**URGENT Field Safety Notice**

**Spectral CT 7500**

**Multi-Function Foot Switch Unload Pedal Foot Entrapment**

March 17, 2023

*Figure 1. Multi-Function Foot Switch Pedal layout*

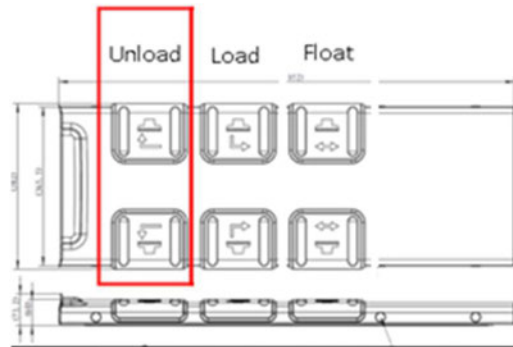
Philips has identified that pressing the Unload Pedal of the foot switch to perform the unload function may cause entrapment of the operator's foot.

Three foot pedals are located on the Multi-Function Foot Switch which can be operated from either side of the patient table. They are located on the floor between the base of the patient table and the gantry. Starting at the base of the table, they include the unload pedal, the load pedal, and the free-float pedal, as shown in Figure 1 and Figure 2.

Philips has received one (1) report of an adverse event associated with this issue, which resulted in bruising to the operator's foot and lower leg. In this reported event, the operator positioned a patient stretcher near the patient table while pressing the *Unload Pedal*. If the operator is positioned in a tight space between the patient table and the ancillary equipment so the operator's range of mobility in removing his/her foot from under the table is limited, then the table downward motion may entrap the operator's foot and lower leg between the bottom of the table, the Multi-Function Foot Switch, and the ancillary equipment. However, please note, the potential for entrapment is not limited to the cited scenario.

- **Immediately stop using the *Unload Pedal*** of the Foot Switch until Philips installs a solution on your system.
  - Instead of using the *Unload Pedal*, please use the *Unload Patient* function on the Gantry Control Panels, or use other *Table In/Out, Up/Down* functions on the Gantry Control Panels, CT Scan Control Box, or Hardware Interventional Controls to fulfill the normal patient unloading function, as instructed in the IFU.
- You may continue to use *Load Pedal*, and *Free-Float Pedal* of Foot Switch, as they are not affected by this Urgent Field Safety Notice Letter.
- Please complete and return the attached response form to Philips promptly and no later than 30 days from receipt. Completing this form confirms receipt of the Urgent Field Safety Notice Letter, understanding of the issue, and required actions to be taken.

Philips will contact you to schedule a time for a Philips Field Service Engineer (FSE) to visit your site and install the solution to resolve this issue (refer to FCO72800795).

Figure 2. Patient Table, Multi-Function Foot Switch, and Gantry layout side view

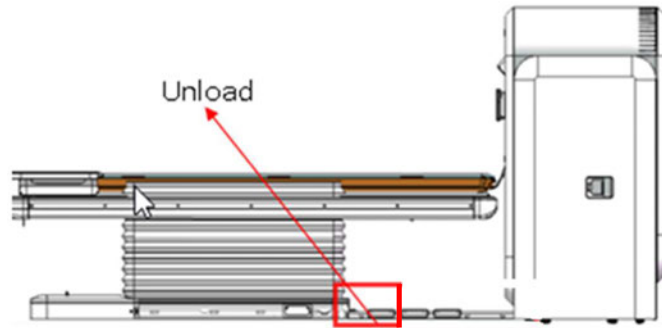
Pressing the *Unload Pedal* will move the patient table out of the Gantry and down to the unload position. The patient table stops moving when the operator releases the *Unload Pedal*, or the unload position is reached.
